USNRC APPLICATION
SUA-1341 License Amendment
Ludeman Project
Converse County, WY

June 2013

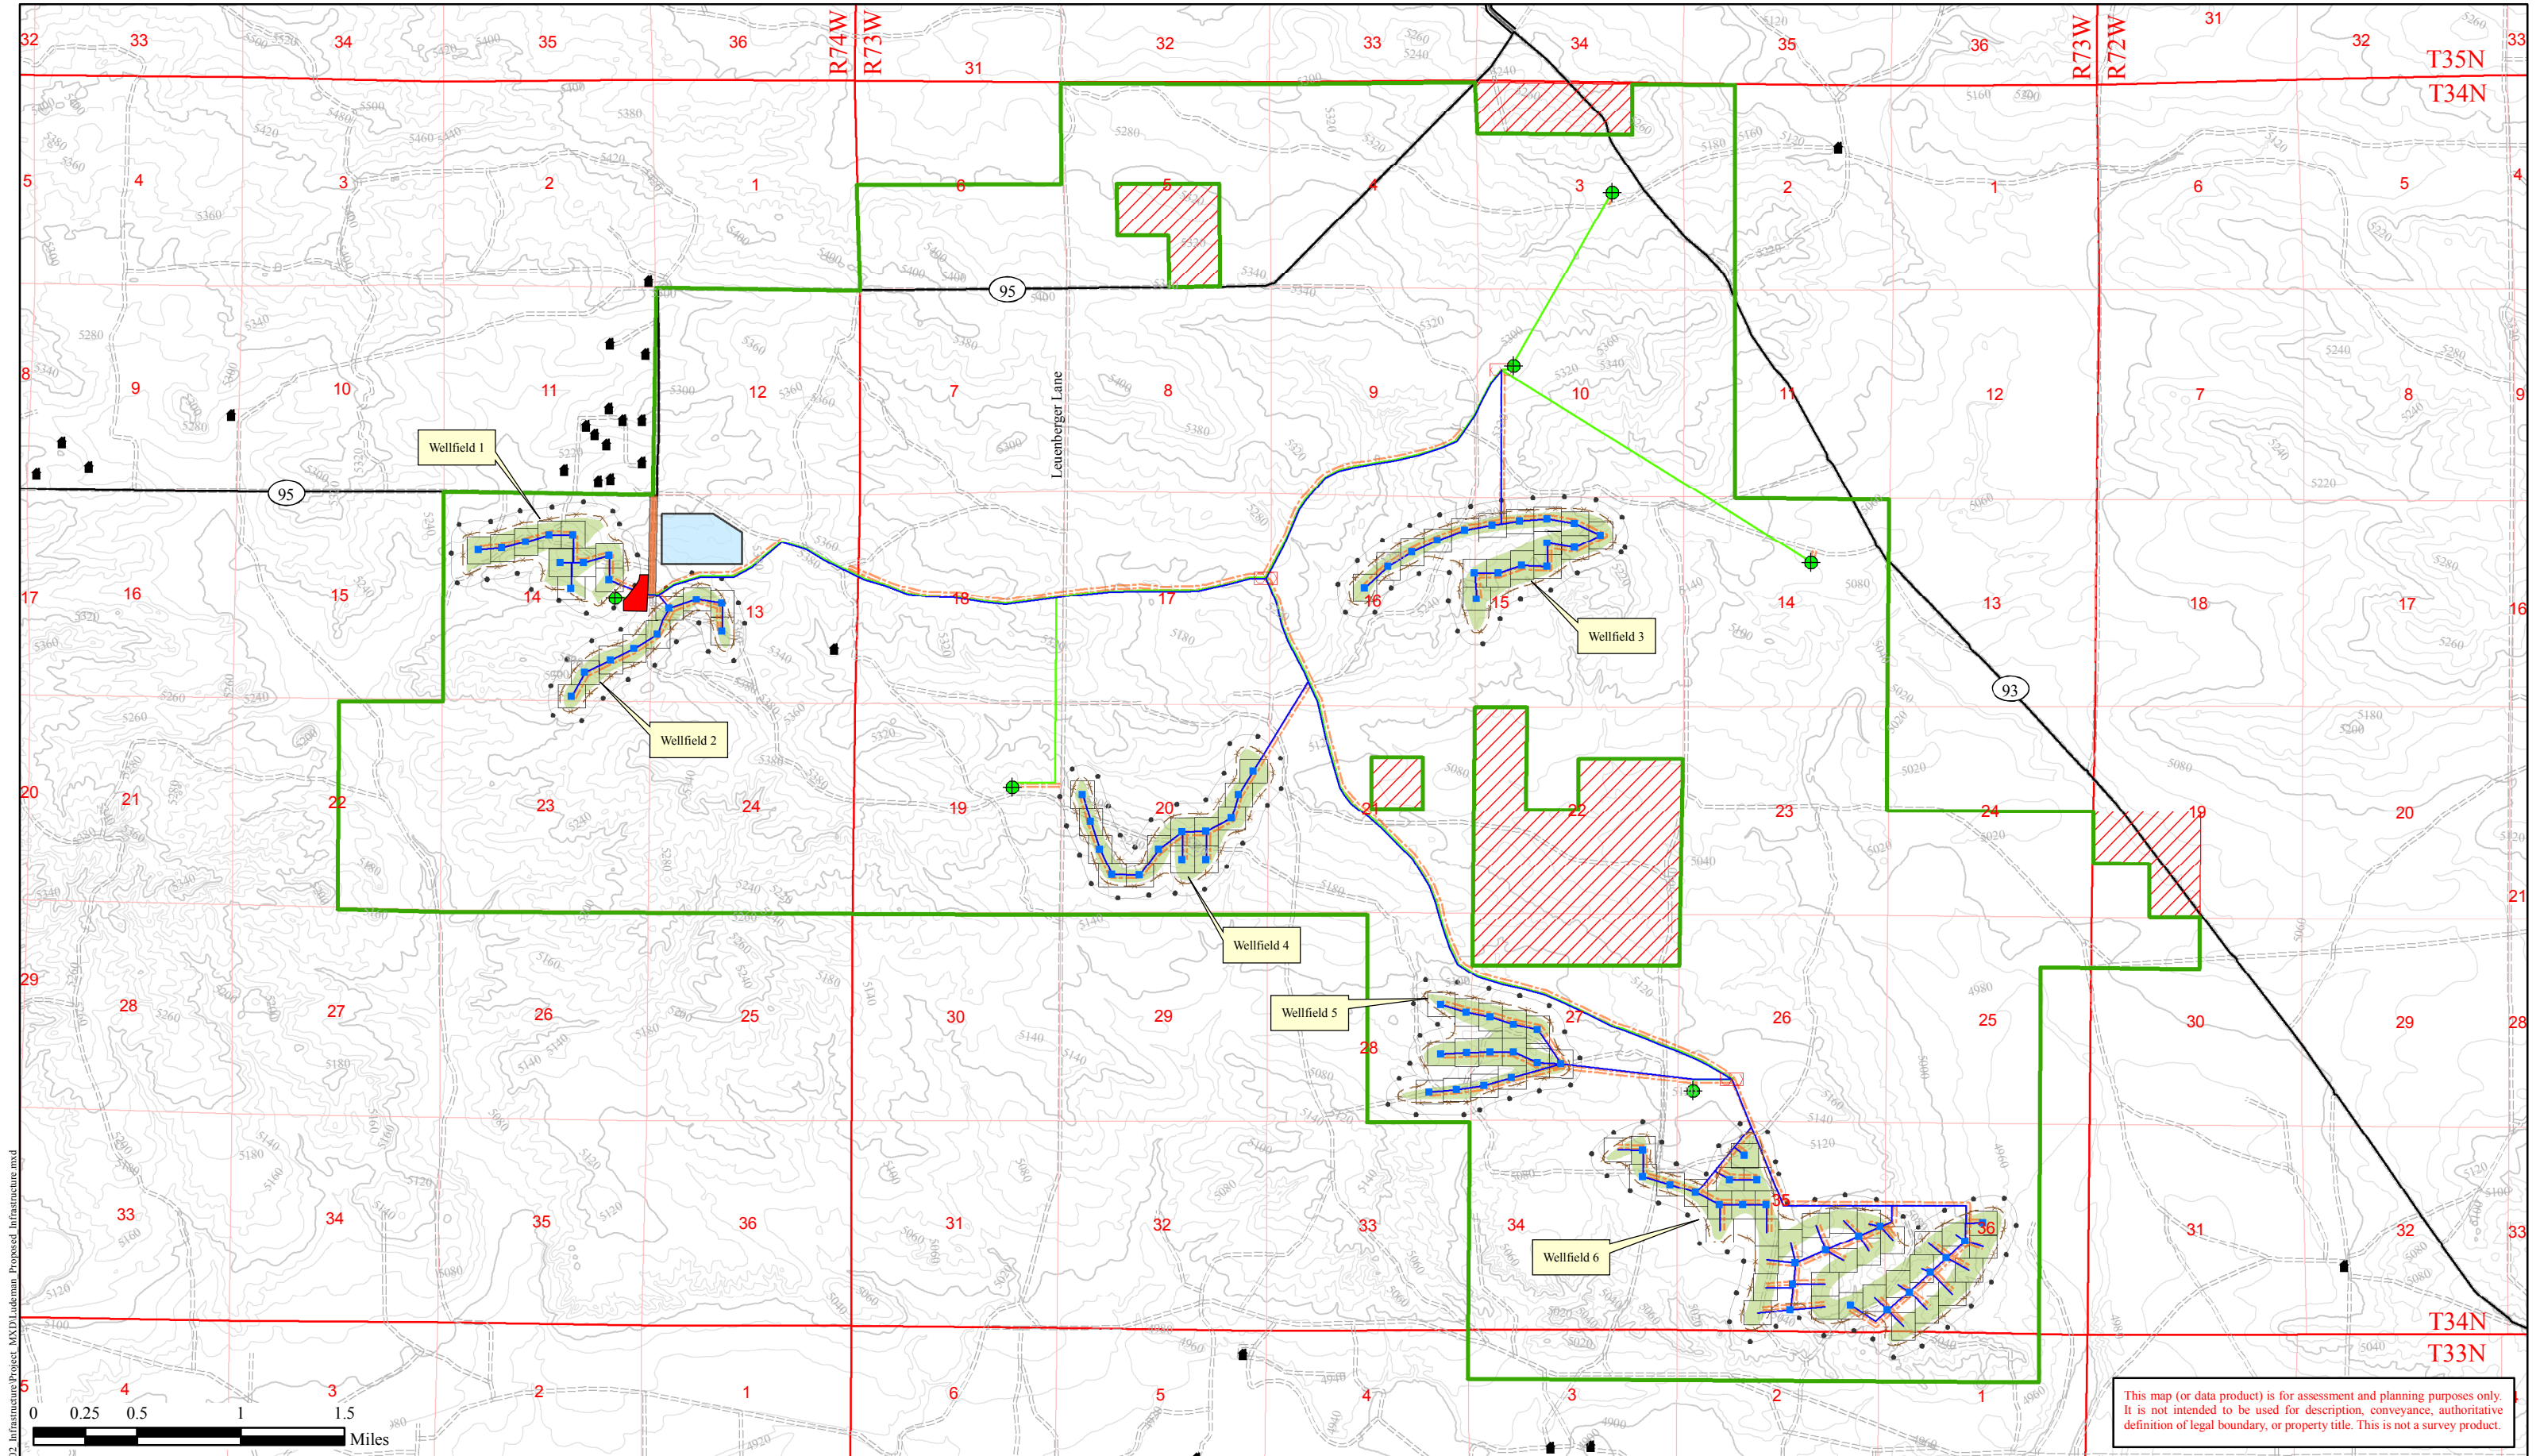
Please maintain the naming convention of Wellfields 1-3 for the Leuenberger Satellite, Wellfields 1-2 for the North Platte Satellite and Wellfields 1-2 for the Peterson Satellite throughout the application and in Section 6.1.5 and Figure 6-1.

Section 6.2.4 states: “As a result, the pre-operation contours shown on Figure 2.1-1 will generally emulate post-production contour.” SRP, Acceptance Criteria 6.2.3(4), requires that the application should include a pre-construction surface contour map and a description of planned surface reclamation activities that will be employed to restore the surface to pre-operations condition. The application includes a pre-operation surface contour map, Figure 2.1-1. However, the map scale does not allow the staff to read the contours and is insufficient to document pre-operation surface contours. In addition, Uranium One should commit to restoring the surface to pre-operation surface contours instead of “restored to a surface configuration that will blend in with the natural terrain, and be consistent with the post mining land use.”

Due to the elimination of the North Platte and Peterson Satellites the naming convention of the wellfields was revised to Wellfields 1-6 to remain consistent with the Ludeman Mine Permit Application submitted to WDEQ/LQD. In addition, Wellfield 3 at the Leuenberger Satellite has been incorporated into Wellfield 1. The figure below depicts the revised infrastructure and wellfield naming convention for the proposed project and will be inserted in TR Section 2.1.

Uranium One has revised the language in Section 6.2.4 of the TR to state reclamation contouring will be “restored to a surface configuration that will blend in with the natural terrain, and be consistent with the pre-operational land use”. This language is consistent with previously NRC-approved license applications. In addition, TR Figure 2.1-1 has been ‘scaled’ properly to assess pre-operation contours. See RAI-102 for revised figure.
